EPA Evaluation of the Glynn-50 Device Under
Section 511 of the Motor Vehicle Information
and Cost Savings Act

Availability of Evaluation Report: An evaluation has been made and the results are described completely in a report entitled: "EPA Evaluation of the Glynn-50 Device Under Section 511 of the Motor Vehicle Information and Cost Savings Act," report number EPA-AA-TEB-511-81-28 consisting of 22 pages including all attachments.

EPA Evaluation of the "Glynn-50" Device under Section 511 of the Motor Vehicle Information and Cost Savings Act

Sketch "A"

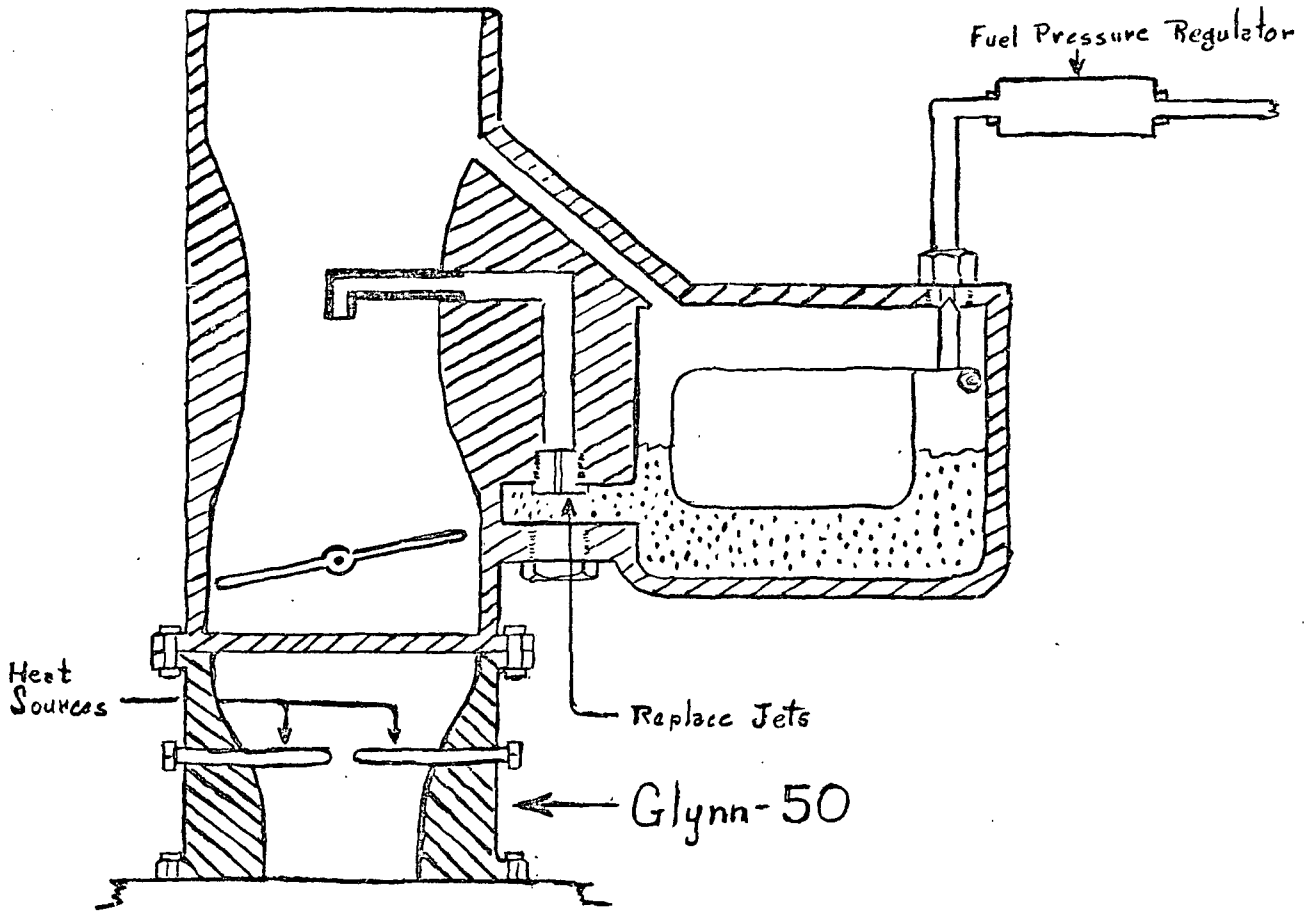
The device is judged to be inadequately described. A brief description is contained under Section 8, Description of Device, of the application (Attachment B).

1. Section No. 8(c) does not provide sufficient descriptive information for the following parameters.
 - a. Fuel pressure regulator: Does one size/design apply to all engines?

- b. Fuel metering jets: Does one size/design fit all carburetors? How much is the diameter of the jet reduced?
 - c. Venturi: Does one size/design fit all engines? How much is the inside diameter of the venturi throat reduced?

- d. Heat source: Does one size/design fit all engines? What is the method of operation (e.g. electric, exhaust gas, etc.)? Is the heat source operating continuously or intermittently? If electric, what is/are the power rating(s)? Is data available which would show the change in temperature of the air-fuel mixture as a result of the heat source? If so, please provide such data.
